ADDENDUM #2 TO BID #16-033

BID NUMBER: 16-033

PROCUREMENT FOR: Underground Steel Belted Conveyor System with Pit at MRF

EQUIPMENT
LAYOUT
(CONCEPTUAL)

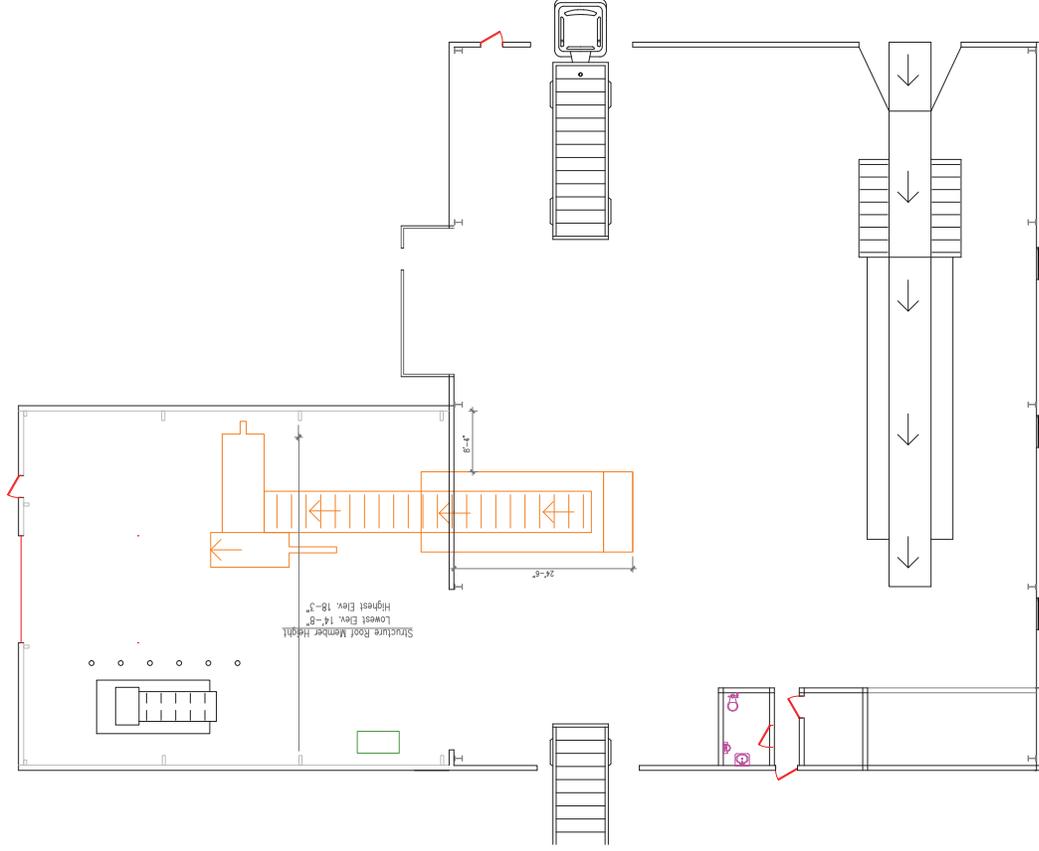
Question 5: Is there a site plan?

Question 6: Do you know where in the building the new conveyor is going to go?

Question 15: Can you please clarify the height/position for the new conveyor?

Question 16: What is the top peak of the building on the side where the new conveyor is to be added?

Answer: The County can provide a general conceptual layout. Please find attached.

Answer: Please refer to the attached conceptual layout. As we saw in the mandatory pre-bid site inspection, there is currently a metal wall separating the building into two halves. Per our discussion during this meeting, the middle area of the wall will be opened up by the Owner to provide space for the deconstruction of the old conveyor and installation of the new conveyor.

Answer: **Please refer to the conceptual drawing attached. Ceiling heights are noted on the attached drawing. See conveyor specifications for additional details.**

Answer: **The top peak of the addition is 18' 3", see conceptual drawing attached.**
